**SUBJECT:** **Cases 23746 & 22896: MPS and Development Agreement Amendments for Seton Ridge - Bedford Highway, Seton Road & Lacewood Drive, Halifax**

**SUBJECT:** **Cases 23746 & 22896: MPS and Development Agreement Amendments for Seton Ridge - Bedford Highway, Seton Road & Lacewood Drive, Halifax**

**Proposed Amendments to the Halifax Municipal Planning Strategy**

Bedford Highway Secondary Planning Strategy  
**Map 9Df – Seton Ridge Neighbourhood Plan**

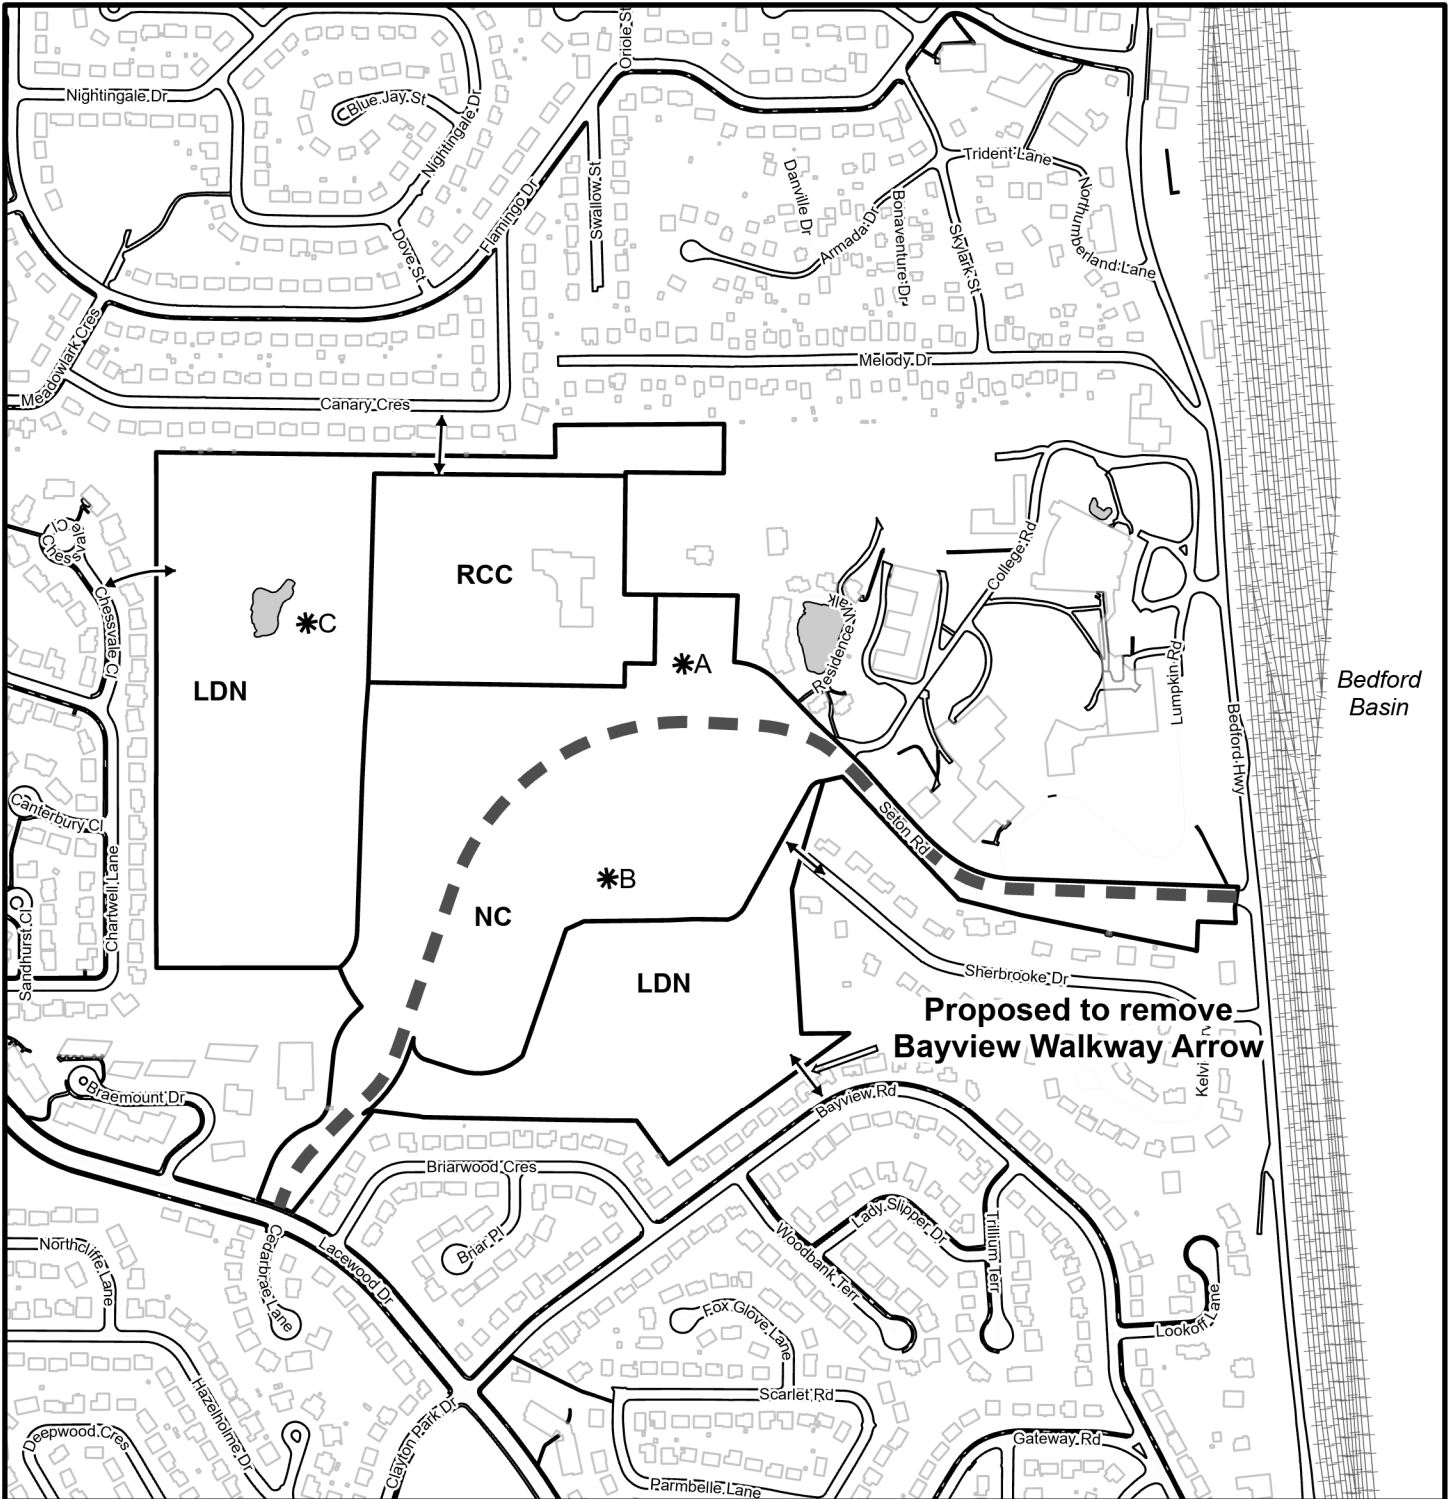
1. Map 9Df of Section VIII (Bedford Highway Secondary Planning Strategy) shall be amended by deleting the arrow which denotes the walkway connection between the Seton Ridge lands and Bayview Road, Halifax, as shown on Schedule A attached hereto.

**Proposed to remove Bayview Walkway Arrow**

# Schedule C2A - Site Plan

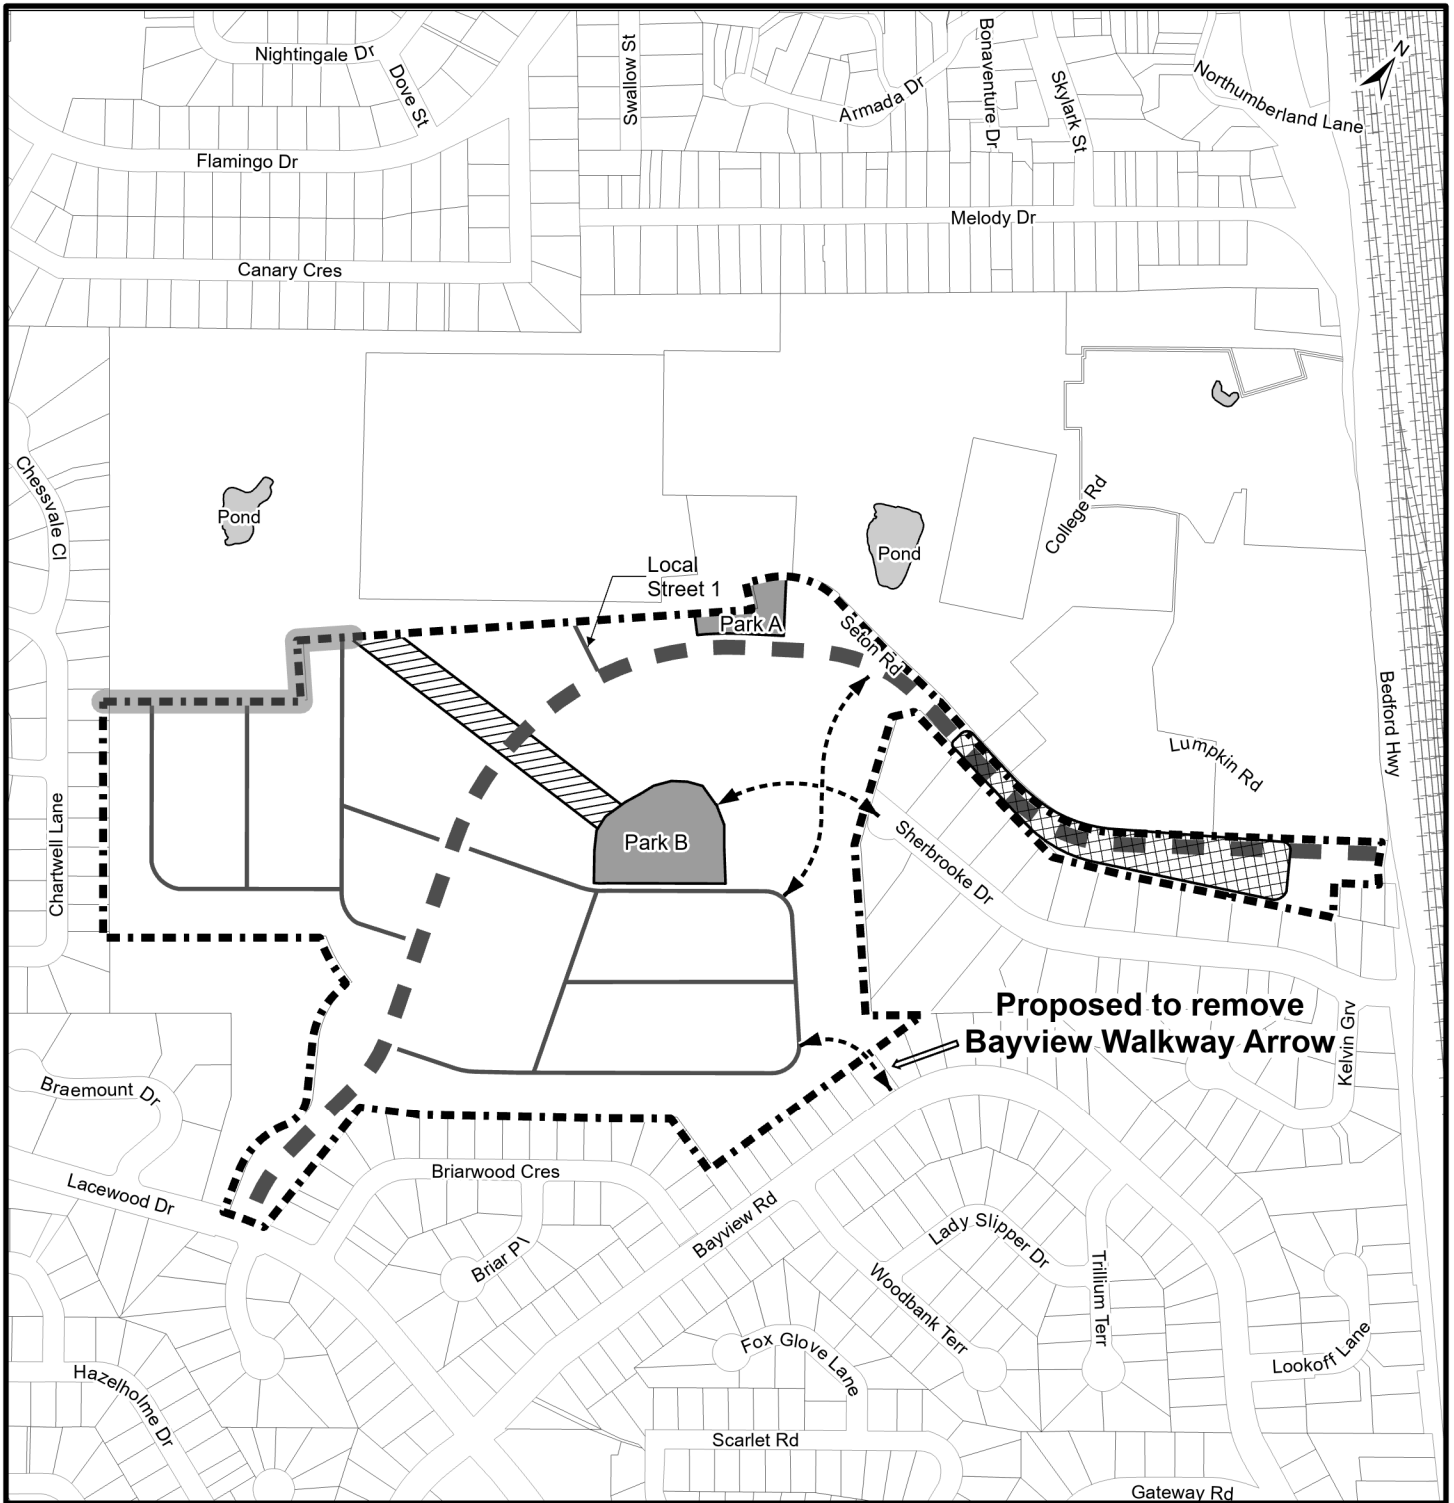
- Amend Schedule C2 of the development agreement to remove the subject walkway linking to Bayview Road. While the existing HRM-owned parcel located on Bayview Road, between civic numbers 77 and 79, was intended as a future walkway, it is too narrow and too steep to allow for the construction of a walkway to HRM specifications. The proposal to omit this walkway on Bayview Drive cannot be considered without an amendment to the Halifax MPS noted above, as the proposed walkways are shown on Map 9Df. However, the land parcel may be necessary for water service purposes, which will be confirmed through the final subdivision process.
